ADELL CENTER PRO JZ18-24 with Rezoning 18.724

ADELL CENTER PRO JZ 18-24 AND ZONING MAP AMENDMENT 18.724

Consideration at the request of Orville Properties, LLC for a Zoning Map Amendment 18.724 for Planning Commission's recommendation to City Council for a Planned Rezoning Overlay Concept Plan (PRO) associated with a zoning map amendment, to rezone from Expo (EXPO) to TC (Town Center). The subject property is approximately 21.48 acres and is located at 43700 Expo Center Drive, north of Grand River Avenue and south of I-96 in Section 15. The applicant is proposing to develop the property as a multi-unit commercial development consisting of nine units accessed by a proposed private drive. The current PRO Concept plan includes a request for an Unlisted Use Determination under Section 4.87 of the Zoning Ordinance.

Figure 2. Wetland Sketch (provided by BWA).

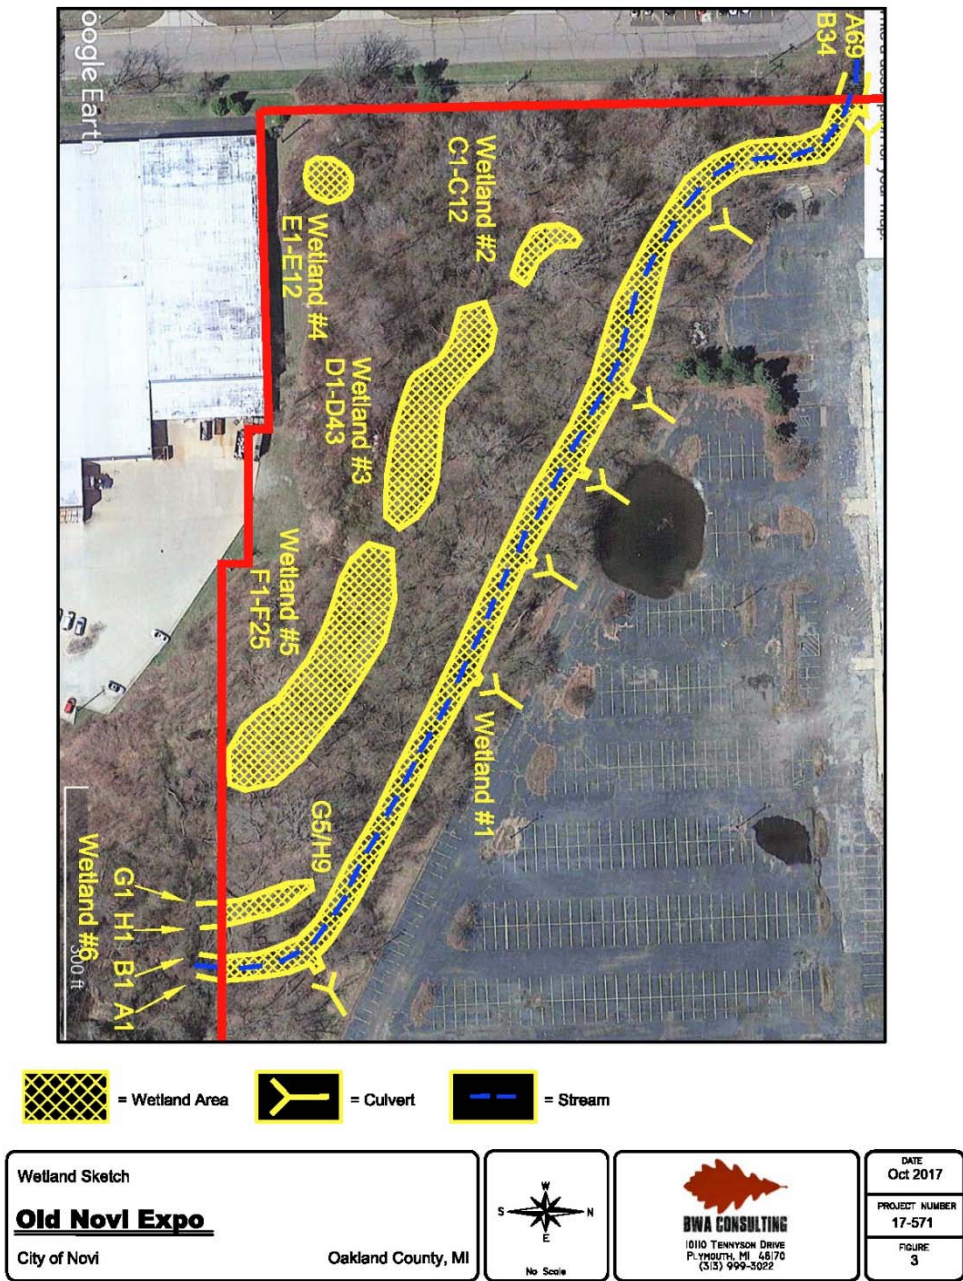
ECT has evaluated the on-site wetlands and believes that they are all considered to be essential/regulated by the City of Novi as they meet one or more of the essentiality criteria (i.e., functions and values) outlined in the City of Novi Wetland and Watercourse Protection Ordinance and regulated by the MDEQ . As noted, the wetlands appear to accurately flagged in the field and appear to be generally indicated accurately on the *Wetland Sketch* provided by BWA (Figure 2, attached).

All six (6) of the on-site wetlands appear to be located within the area depicted as regulated wetland on the City of Novi Regulated Wetland and Watercourse Map (Figure 2). ECT has evaluated each wetland and believes that each wetland is regulated by the City's Wetland and Watercourse Protection Ordinance because all on-site wetlands are located within 500-feet of the Walled Lake Branch of the Middle Rouge River.
